**ADDENDUM NO. 2**

February 25, 2013

RE:           **Kitchen Improvements at Kirk Middle School**  
                  140 Brennen Drive, Newark, Delaware 19713

for  
                  **Christina School District**  
                  700 North Lombard Street, Wilmington, Delaware 19801  
                  EIA Project No. PP7279

<p>TITLE: <b>DETAIL B/A1</b></p>		<p>ISSUE DATE 20 FEB 2013</p>
<p>PROJECT: <b>KIRK MIDDLE SCHOOL</b> 140 BRENNEN DRIVE NEWARK, DE 19713 <b>CHRISTINA SCHOOL DISTRICT</b></p>		<p>EIA PROJECT NO. PP7279</p> <p>PDE PROJECT NO.</p>
<p><b>EI ASSOCIATES</b></p>		<p>EIA DRAWING NO. <b>ASK1</b></p>

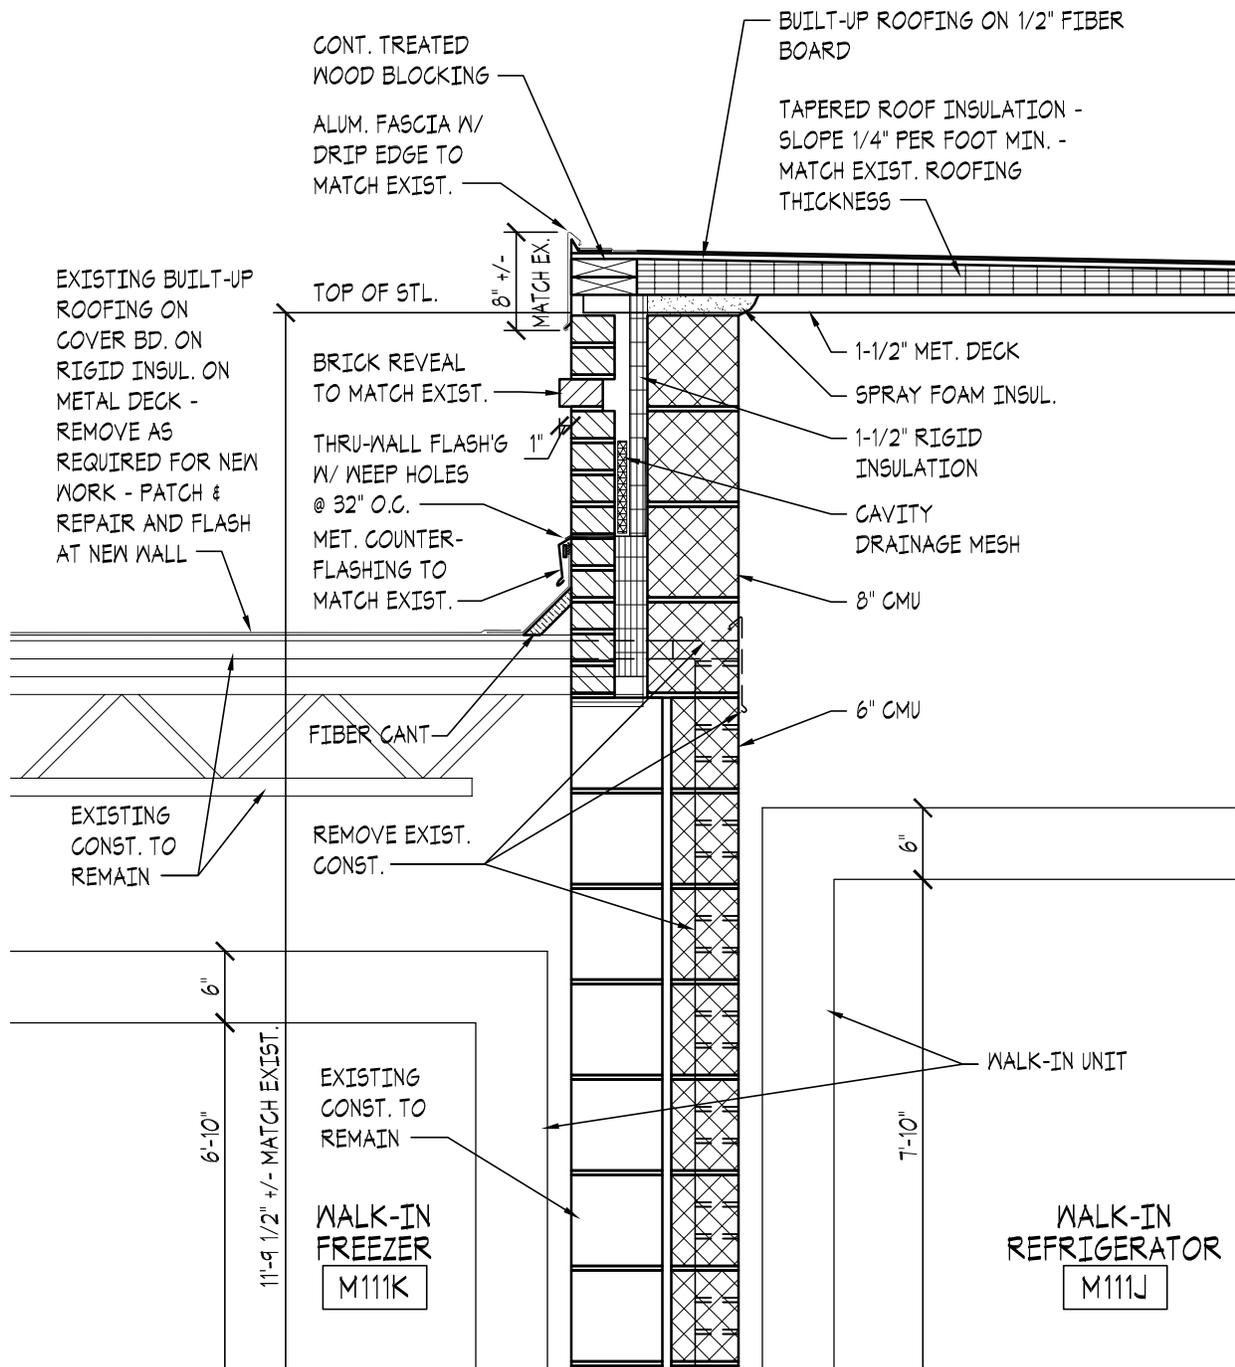
- 2.13 Drawing A1; Floor and Roof Plans: Add references to Detail B/A1 at west wall of Walk-in Refrigerator M111J in area of new addition.
- 2.14 Drawing A1: Add Detail B/A1 as shown on supplemental Drawing ASK1, copy of which accompanies this addendum.

EIA DRAWING NO.  
SSK1

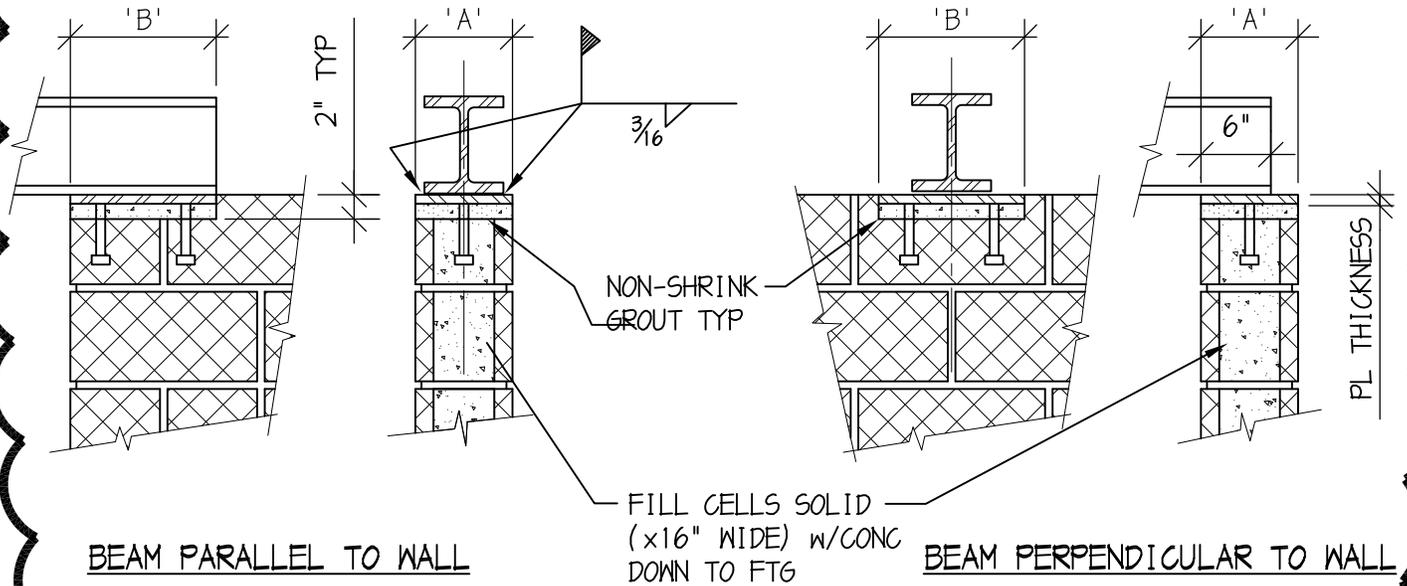
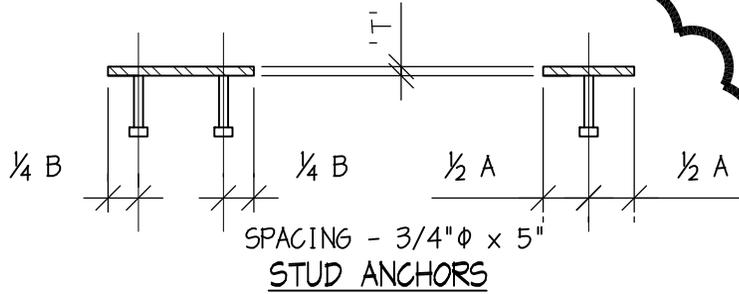
- 2.20 Drawing S2.1; Foundation Plan 1/S2.1: In note regarding 4" slab on grade, add the word “BARRIER” after the word “VAPOR.”
- 2.21 Drawing S2.1: Add Typical Detail 14/S2.1 as shown on supplementary Drawing SSK1, copy of which accompanies this addendum, to show wall bearing details for new steel beams.

EIA DRAWING NO. **ESK-1**

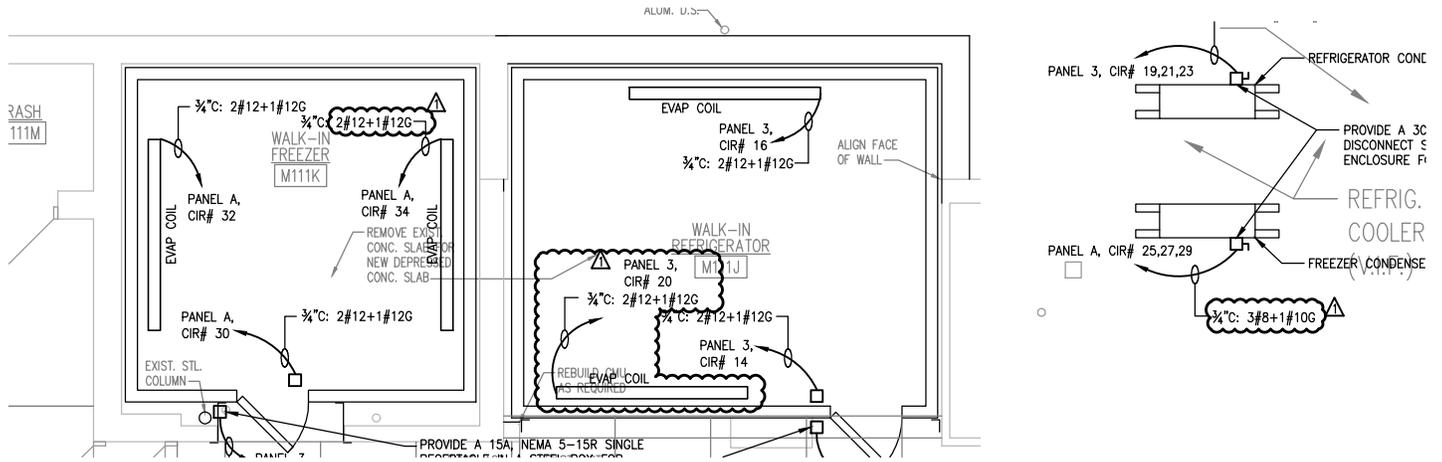
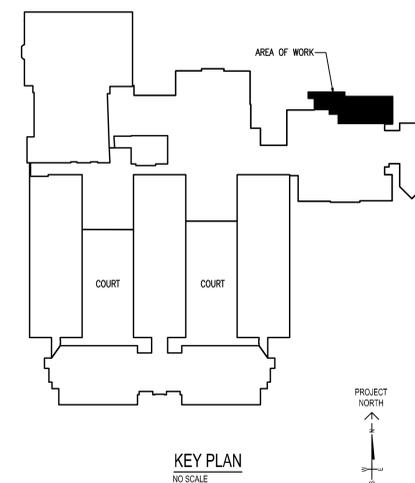
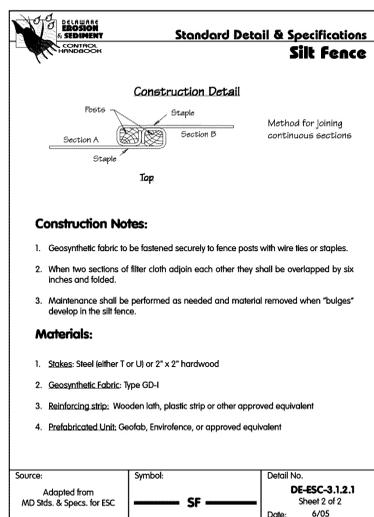
- 2.23 Drawing E1: Revise Partial Floor & Roof Plans and Existing Power Panel Schedules as shown by clouded marks on supplemental Drawing ESK-1, copy of which accompanies this addendum.
